Access Compliance Report

Public Rights-of-Way

(Curb Ramps)

Intersection ID: N/A	Main Street: SOLAR_WY	Cross Street: ROCK_ISLAND_RD	Location: NE
ADA ID: 10C6CEBE1CF6	Ramp Type: Perp	Initial Pass/Fail: Fail	Overall Compliance: No
Codes/Mitigation Info/Possible Solution		Field Measurements/Component Compliance	
Severity Score: 12.5

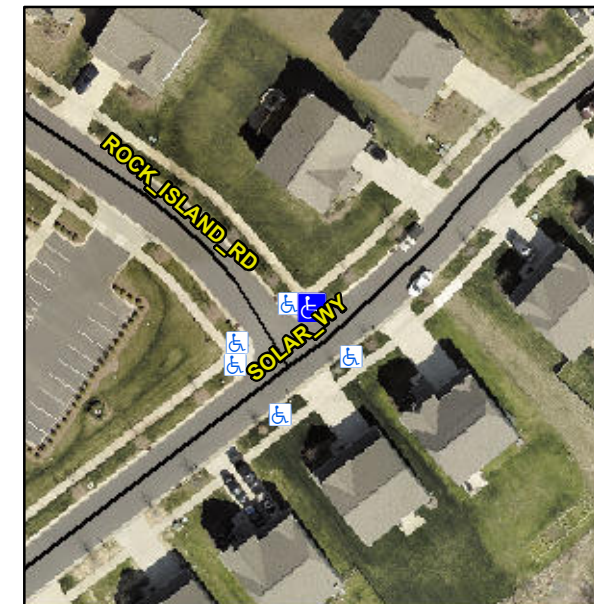
Not Found, R304.5.3

Compliance	Description	Data	Compliance	Description	Data
N/A	Ramp Length (in)	95.0	Yes	Ramp Slope (%)	7.2
Yes	Ramp Width (in)	48.0	No	Ramp XSlope (%)	6.1
N/A	Flare Type LT	N/A	N/A	Flare Type RT	N/A
N/A	Flare Slope LT (%)	N/A	N/A	Flare Slope RT (%)	N/A
N/A	Flare Traversable LT?	N/A	N/A	Flare Traversable RT?	N/A
N/A	Landing Length (in)	N/A	N/A	DWS Provided?	N/A
N/A	Landing Width (in)	N/A	N/A	DWS Contrast?	N/A
N/A	Landing Slope (%)	N/A	N/A	DWS Length (in)	N/A
N/A	Landing X Slope (%)	N/A	N/A	DWS Full Width?	N/A
N/A	Landing Curb? (Y/N)	N/A	N/A	DWS Offset (in)	N/A
N/A	Shared Landing?	N/A			
N/A	Gutter Ponding?	N/A	N/A	Gutter Slope (%)	N/A
N/A	Gutter Lip Ht (in)	N/A	N/A	Gutter X Slope (%)	N/A
N/A	Painted X Walk1?	No	N/A	Painted X Walk2?	N/A
	X Walk 1 Direction	To SE		X Walk 2 Direction	N/A
N/A	X Walk 1 Width (in)	N/A	N/A	X Walk 2 Width (in)	N/A
	X Walk 1 Slope (%)	4.5		X Walk 2 Slope (%)	N/A
	X Walk 1 X Slope (%)	4.7		X Walk 2 X Slope (%)	N/A

Remove & Replace Entire Ramp.
